# Access Compliance Report

## Public Rights-of-Way

### (Curb Ramps)

Intersection ID: 3757	Main Street: DAVIS_LAKE_PY	Cross Street: POPLAR_GROVE_DR	Location: SE
ADA ID: F19D3BFF0ECC	Ramp Type: Perp	Initial Pass/Fail: Fail	Overall Compliance: No
Severity Score: 26.25			
Codes/Mitigation Info/Possible Solution		Field Measurements/Component Compliance

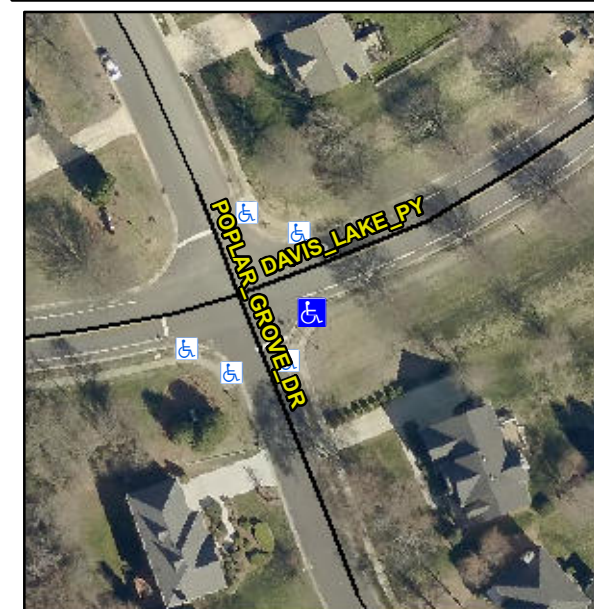
**Not Found, R304.2.2, R304.5.3**

Compliance	Description	Data	Compliance	Description	Data
N/A	Ramp Length (in)	48.0	No	Ramp Slope (%)	16.5
Yes	Ramp Width (in)	48.0	No	Ramp XSlope (%)	4.1
N/A	Flare Type LT	N/A	N/A	Flare Type RT	N/A
N/A	Flare Slope LT (%)	N/A	N/A	Flare Slope RT (%)	N/A
N/A	Flare Traversable LT?	N/A	N/A	Flare Traversable RT?	N/A
N/A	Landing Length (in)	N/A	N/A	DWS Provided?	N/A
N/A	Landing Width (in)	N/A	N/A	DWS Contrast?	N/A
N/A	Landing Slope (%)	N/A	N/A	DWS Length (in)	N/A
N/A	Landing X Slope (%)	N/A	N/A	DWS Full Width?	N/A
N/A	Landing Curb? (Y/N)	N/A	N/A	DWS Offset (in)	N/A
N/A	Shared Landing?	N/A			
N/A	Gutter Ponding?	N/A	N/A	Gutter Slope (%)	N/A
N/A	Gutter Lip Ht (in)	N/A	N/A	Gutter X Slope (%)	N/A
N/A	Painted X Walk1?	No	N/A	Painted X Walk2?	N/A
	X Walk 1 Direction	To N		X Walk 2 Direction	N/A
N/A	X Walk 1 Width (in)	N/A	N/A	X Walk 2 Width (in)	N/A
	X Walk 1 Slope (%)	4.0		X Walk 2 Slope (%)	N/A
	X Walk 1 X Slope (%)	0.1		X Walk 2 X Slope (%)	N/A

**Remove & Replace Entire Ramp.**
